Review of Wagga Wagga Floodplain Risk Management Study & Plan

Reference: R.A10413.001.06.WaggaWagga_FRMS_Review.docx

Date: July 2022

Final Report

Figure 3-2 Histogram showing the distribution of difference in elevations between the 2009 LiDAR and FRMS&P 2018 values for residential properties

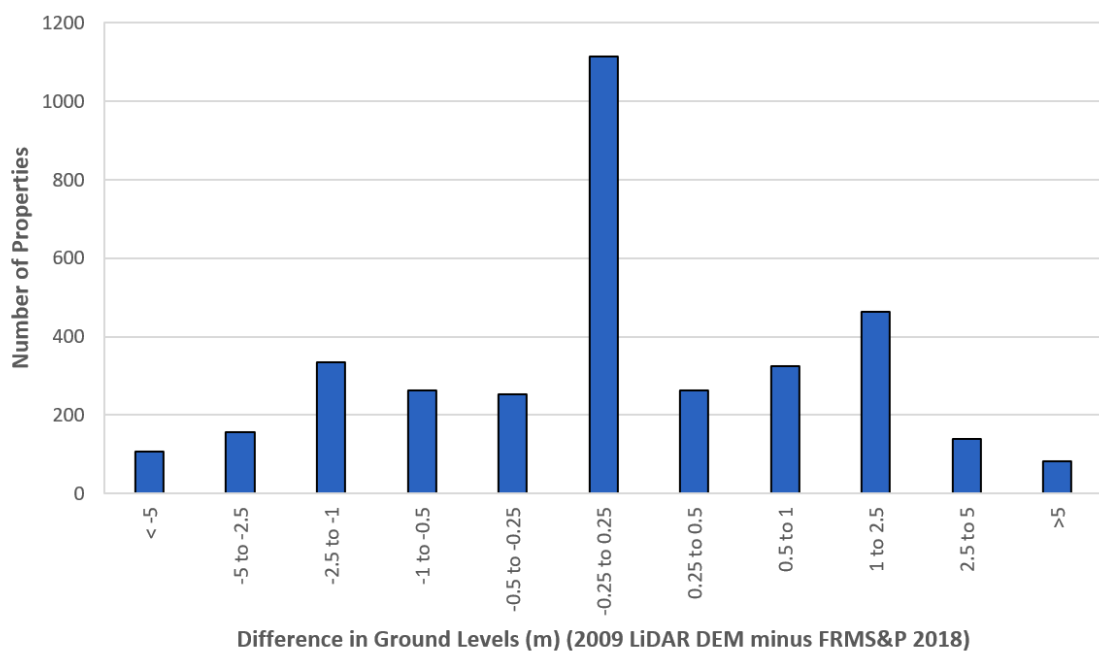
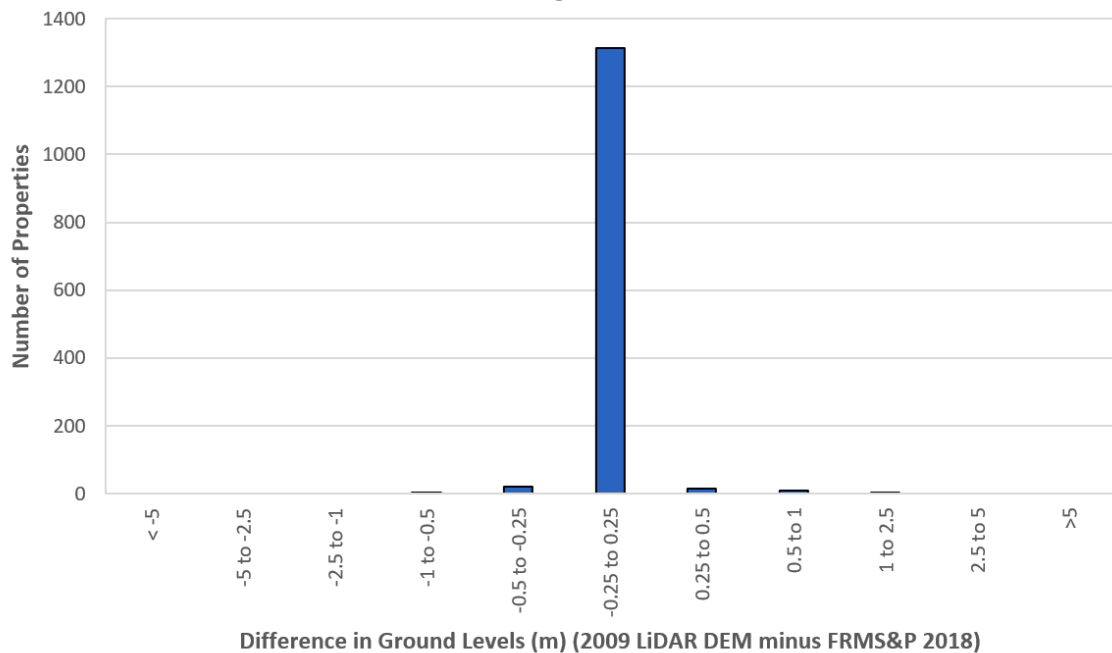
LiDAR DEM at the quoted X and Y coordinates is provided in Figure 3-2. This histogram quantifies the spread and magnitude of the variation and helps to understand the potential influence of this issue. For comparison, a similar histogram is also provided in Figure 3-3 for the non-residential properties. Note that the difference refers to the 2009 LiDAR elevation minus the elevation within the damage calculation spreadsheet.

The greater impacts on damage calculations at a property level would occur as a result of the property being newly impacted above ground and/or above floor, or alternatively no longer impacted above ground and/or above floor. However, the overall impact of this issue across the whole study area may result in a minor net change in total intangible damages or alternatively, may result in a significant net change in total tangible damages.

ID	Recommendation	Issue Type	Issue Significance	Timing
3-2	Review and rectify errors in property database, in particular floor levels. Update all subsequent study components that rely upon the property database up to and including options assessment and the FRMP. Update all relevant report sections and add clarification on methodology used and source of data upon which the assessment is based.	Error	High	FRMS&P 2018

Figure 3-6 North Wagga Levee breach locations (shown as orange polygons)

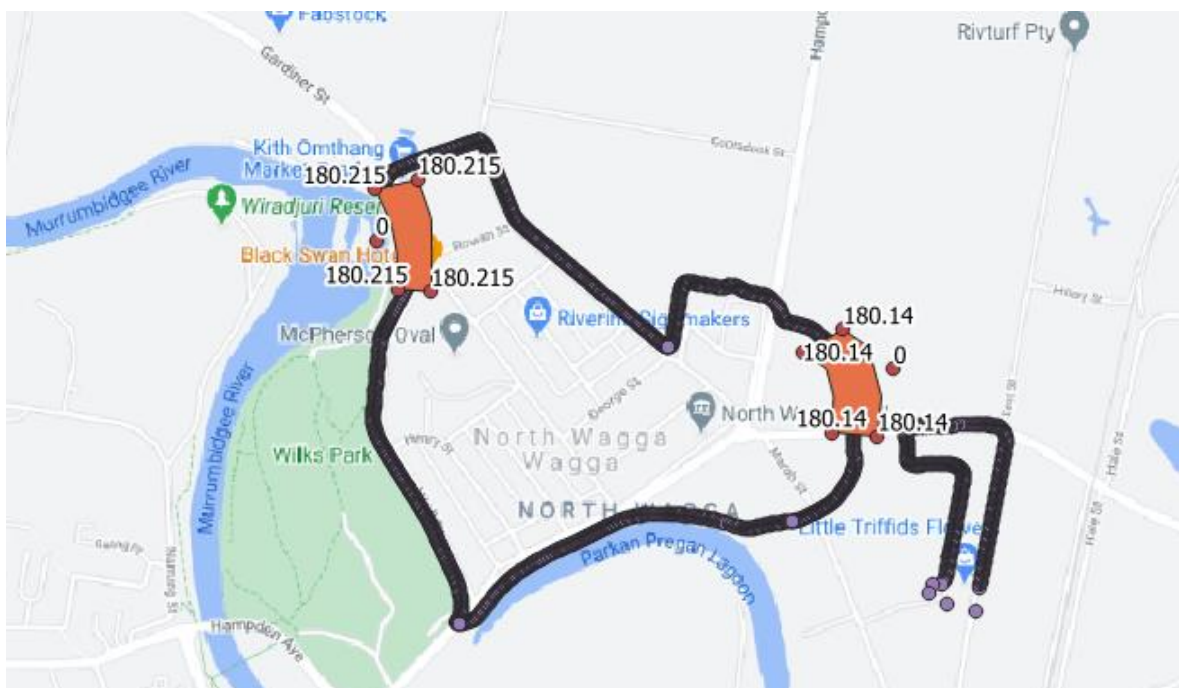
The breach of the existing North Wagga Levee is modelled by reducing a 100 m section on each side of the levee (upstream and downstream) to a level halfway between natural surface and the existing level of protection to allow controlled failure to occur. The breach is modelled in TUFLOW as a “variable Z shape”. Essentially, TUFLOW 2D model topography is varied over time to represent embankment failure when the water level reaches a specified height (in this case the design level of protection) at a specified trigger location (refer modelled breach locations in in Figure 3-6).

Under North Wagga Levee upgrade scenarios (i.e. Option L3(A-C) and L4(A-C)), the North Wagga Levee was reported within the FRMS&P 2018 to be modelled using the same approach as for the Wagga CBD Levee (described in Section 3.4.1) because the upgrades would include formal spillway designs. However, it is noted that the report does not define what portion of freeboard is removed from the spillways and the remaining freeboard that has been modelled for North Wagga Levee upgrades. Contrary to what was reported, the North Wagga Levee upgrade Option L4(B) was found to be hydraulically modelled based on a similar approach as the modelling of the existing scenario. That is, a breach was modelled by reducing a 100 m section on each side of the levee (upstream and downstream) to a level halfway between natural surface and the proposed level of protection to allow controlled failure to occur. A levee freeboard of between 0.3 and 0.6 m was found to be modelled (refer Section 4.3.2).

Damage values will be greater in areas protected by levees as a result of the FRMS&P 2018 approach. Therefore, this approach is considered to provide conservative damage estimates within levees, particularly within the Wagga CBD Levee because:

ID	Recommendation	Issue Type	Issue Significance	Timing
3-4	Correct inconsistency between reported methodology and implementation within the modelling undertaken in relation to freeboard and levee failure for North Wagga. Undertake a sensitivity assessment to re-model reported freeboard and approach and determine impact on results and damages. If sensitivity results are not actionable, as a minimum, update report to be consistent with actual modelling implementation. If actionable, update assessment and all subsequent tasks.	Error	High	FRMS&P 2018
3-5	Undertake a sensitivity assessment of the following scenarios: 1. Full freeboard with no levee failure; 2. Full freeboard with partial (upstream) levee failure.	Future opportunity	Medium	Future

Figure 4-1 Modelled Levee Crest Elevation vs Design Flood Levels

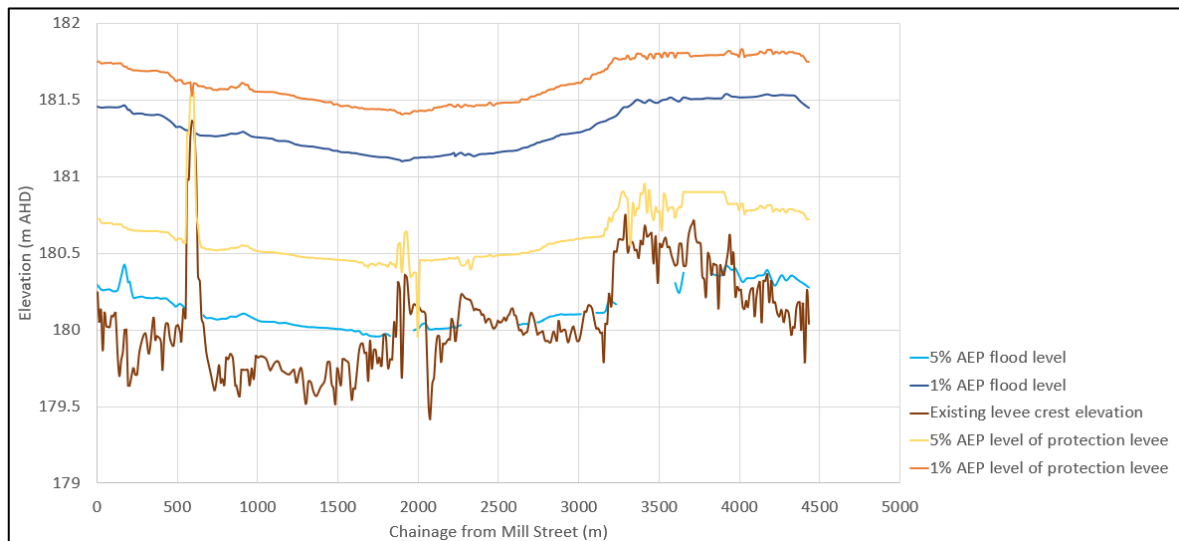
The FRMS&P 2018 report states that a freeboard of 0.75 m was recommended for the North Wagga Levee (Public Works, 2010), however Section 9.3.3.1 of the FRMS&P 2018 states that the proposed North Wagga Levee options include a freeboard of 0.7 m. Within the modelling, the crest of the levee is above the designed AEP flood level, with the freeboard generally varying between 0.3 m and 0.6 m based on a comparison of modelled levee elevations against modelled design flood levels. This is shown in Figure 4-1.

Therefore, neither the recommended nor reported levee freeboard is reflected in the modelling. Furthermore, the modelled freeboard for the no failure scenario was found to be the same as the modelled freeboard for the failure scenario for North Wagga Levee options (albeit without the spillway lowering). This finding is valid for modelling of all North Wagga Levee options but is in conflict with the approach reported in the FRMS&P 2018.
